February 15, 2017
E-47395

Subject: Application for Revision 9 to Certificate of Compliance No. 9301, Docket 71-9301, for the Model TNF-XI, Request for Additional Information, TAC Number 25158

**RAIs and Responses
(Non-Proprietary Version)**

Figure 2-1
Packaging View Showing Bora Resin

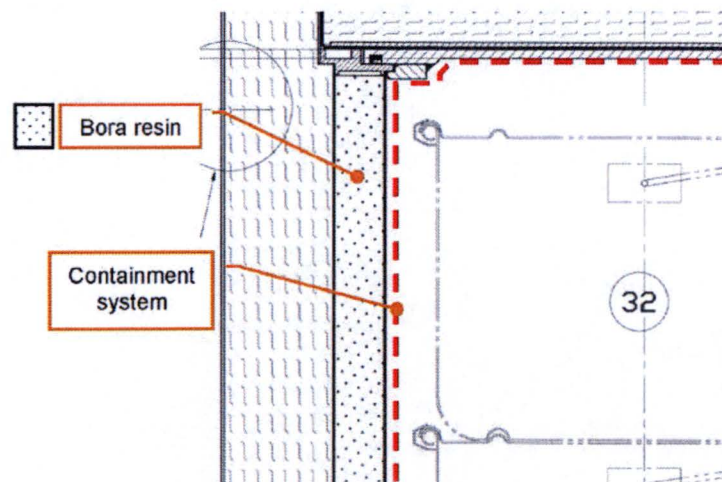
Provide the basis that pyrophoricity is prevented with Content 7.

Content 7 has scrap, and residues of incinerator ashes or earth, sand and residues from dissolution. Additionally, the aluminum impurity level is up to 5000 ppm in the uranium oxide powder. ASTM C753 limits 300 ppm of aluminum impurity. As the scrap is less than sub-mm (or scrap spherule radius of 0.10 cm) in size and may include aluminum, it is unclear whether the scrap is well inerted without moisture or oxygen to prevent potential pyrophoricity. Additionally, the applicant conservatively assumed in qualification at normal conditions that the mass loss of Bora resin is due to water evaporation. The applicant should justify that any water generated due to degradation of Bora resin or plastic bags will not react with powdered metals in the content, which may result in pyrophoric conditions.

This information is needed to determine compliance with the requirements of 10 CFR 71.43(d).

Aluminum metal present in the residues before incineration is in the form of sheet metal that is around 35 μm thick. Because the incineration temperature is around 800 $^{\circ}\text{C}$, it is considered that the total amount of aluminum present in the residues will occur in the form of oxides. The very small thickness of the aluminum material is favorable to the complete oxidation of the material. Therefore, the risk of pyrophoricity is excluded for the content number 7.

As shown in the figure below, the presence of Bora resin outside the containment system is evidence that water evaporation coming from the Bora resin cannot be directly in contact with the powdered metals.

In Chapter 3 of the Safety Analysis Report (SAR), it is demonstrated that the maximum temperature of the pails, and then of the plastic bags (accident conditions), is 100 °C (assessment in a penalizing way). Therefore, neither gas emissions coming from the plastic bag in accident conditions, nor subsequent pyrophoric conditions, are expected.
